From: Stevens, Richard [mailto:Richard.Stevens@wsp.com]
Sent: 13 November 2017 15:29
To: Victoria Gibson <Victoria.Gibson@RBWM.gov.uk>; Remsha Mohammed-Remla <Remsha.Mohammed-Remla@Projectcentre.co.uk>
Cc: Wheeler, Martin <Martin.Wheeler@wsp.com>; Phil Rowe <Phil.Rowe@Kerrington.co.uk>; Ian Dobie <Ian.Dobie@farmglade.co.uk>
Subject: Phoenix Gymnastics Club - planning ref 17/00997CONDIT.

Please find attached drawings illustrating the new proposals for surface water drainage at Phoenix Gymnastics Club following the meeting held on 13th October 2017. We trust these are in line with the approach agreed at the meeting and the meeting minutes which Martin contributed to last week. These comprise:

- General arrangement drawing (9443-D-01) showing proposed changes to the surface water drainage system
- Key Sections drawing (9443-D-02); and,
- Amended Below Ground Drainage Layout – Drawing 667769-DWG-SBU-C-100.

Drawing No. **667769-DWG-SBU-C-100** Rev **P3**

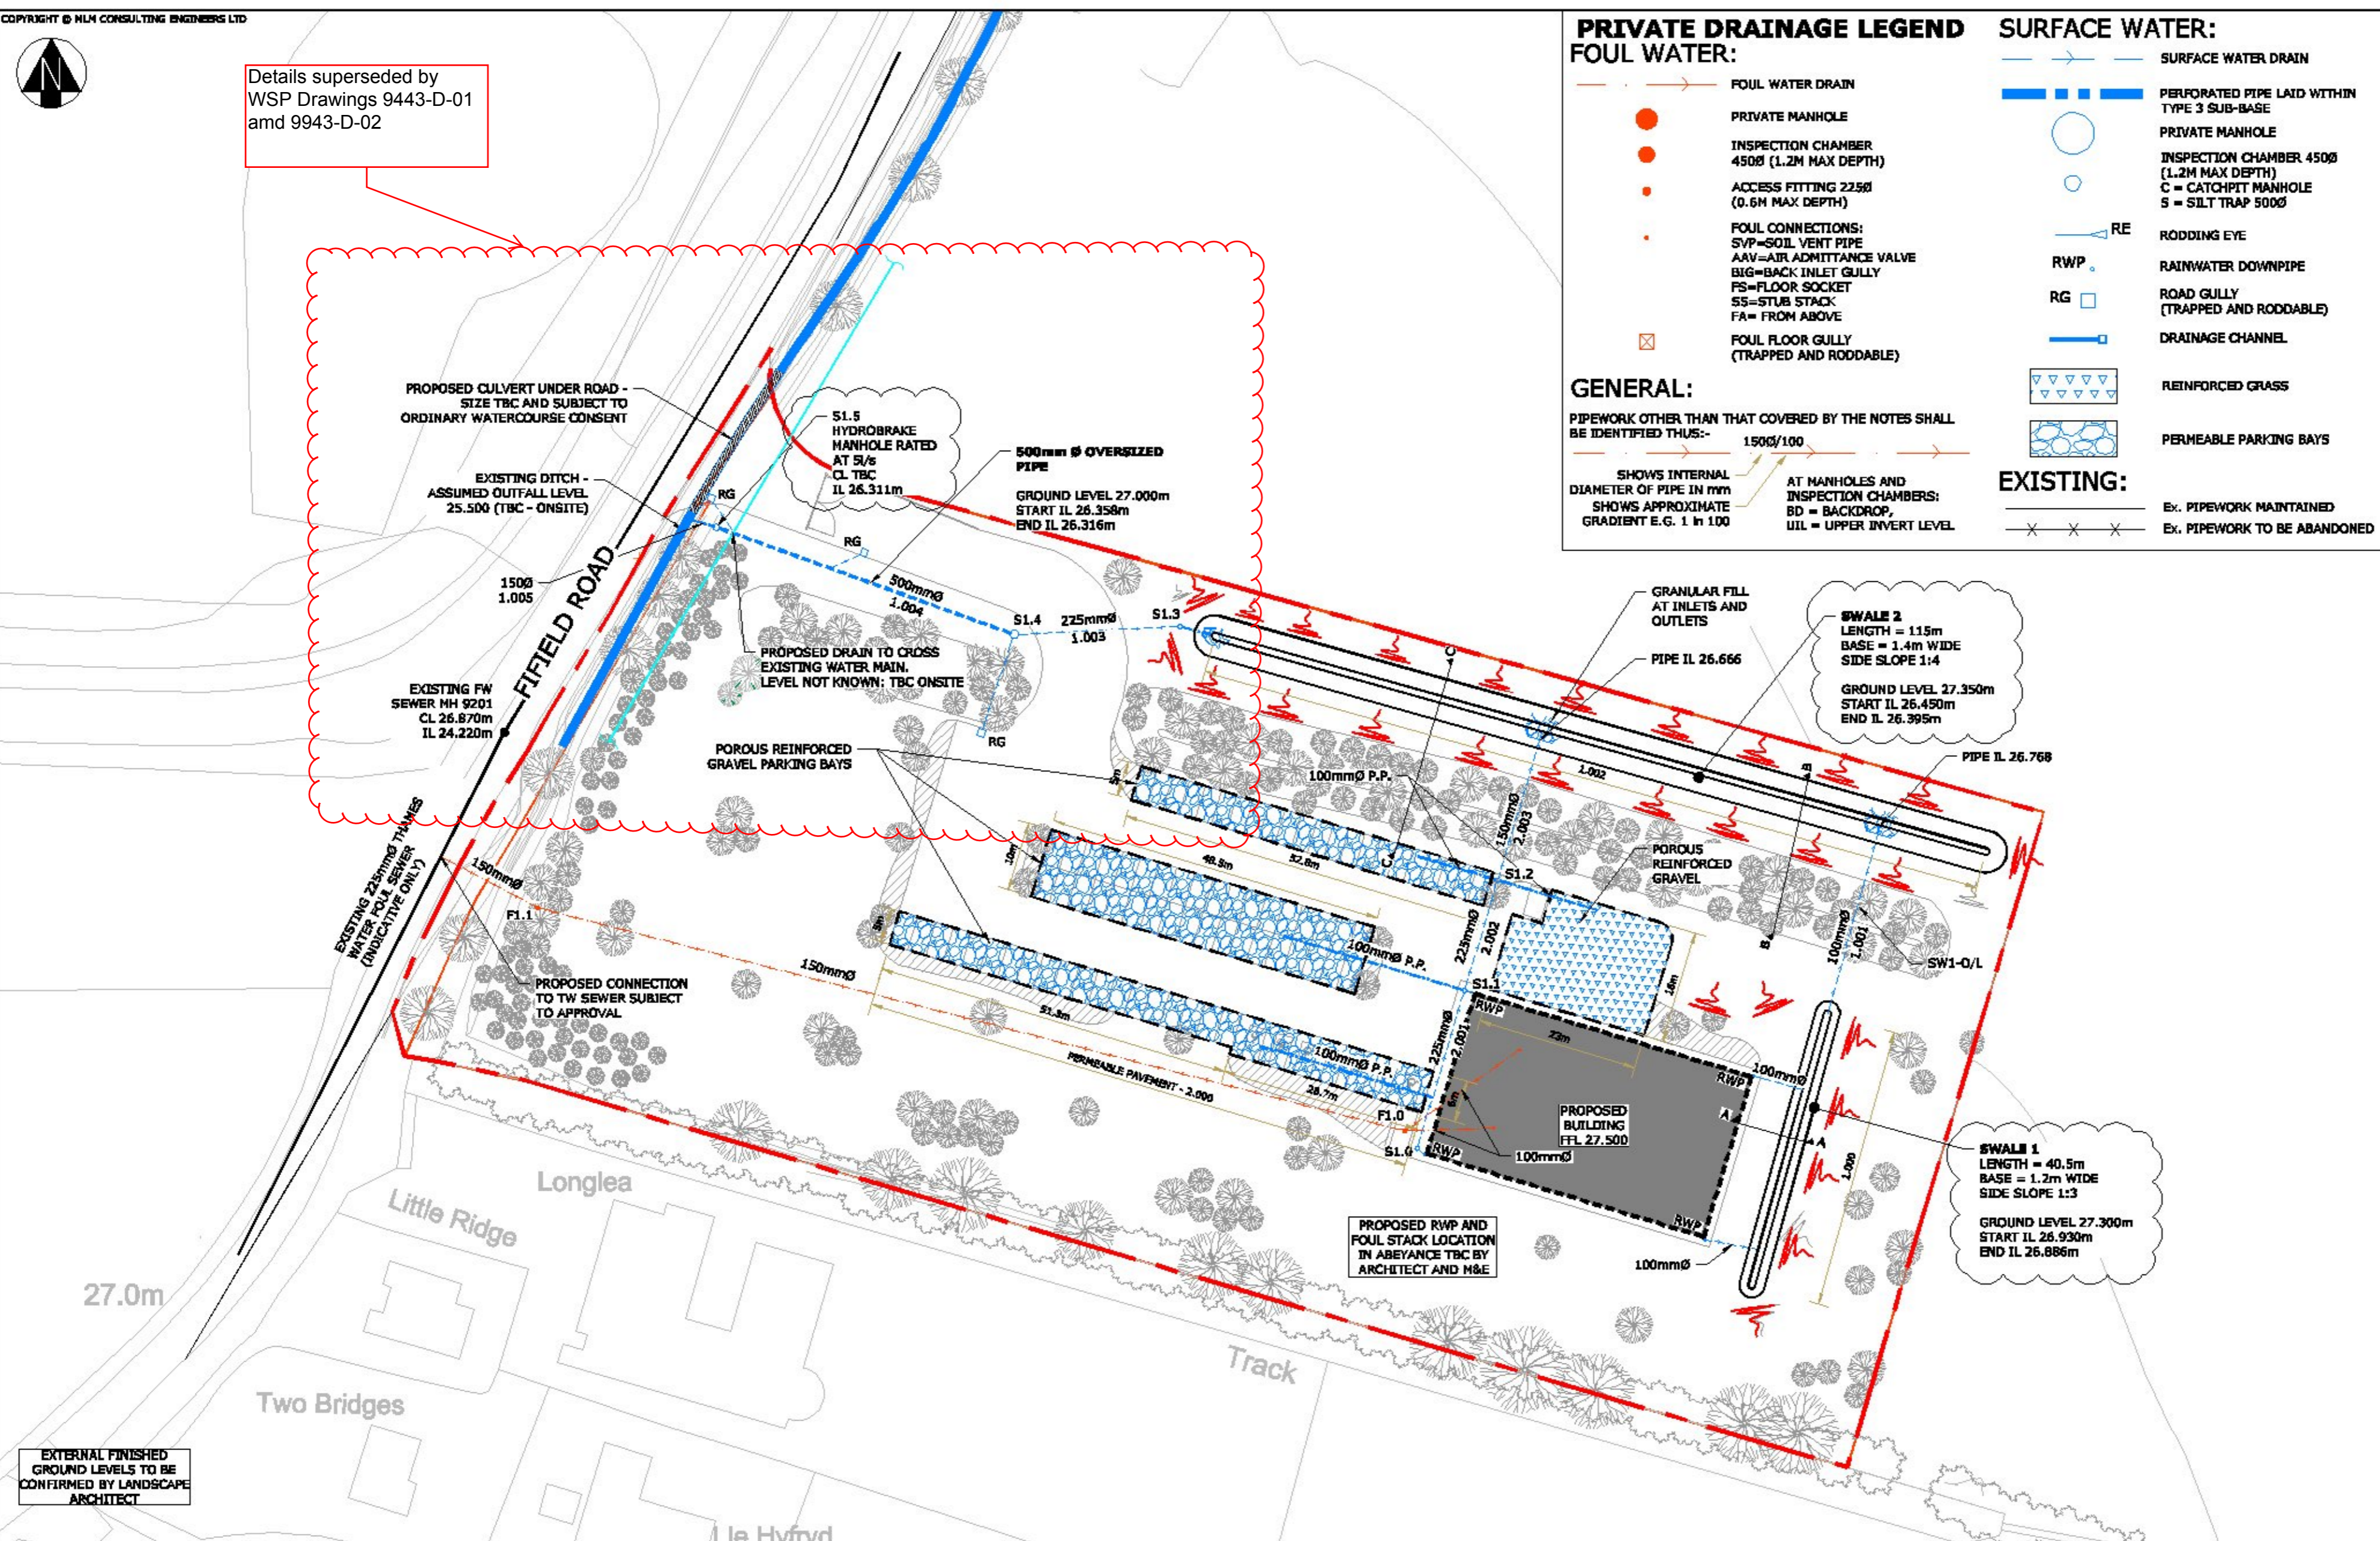
Details superseded by WSP Drawings 9443-D-01 and 9943-D-02
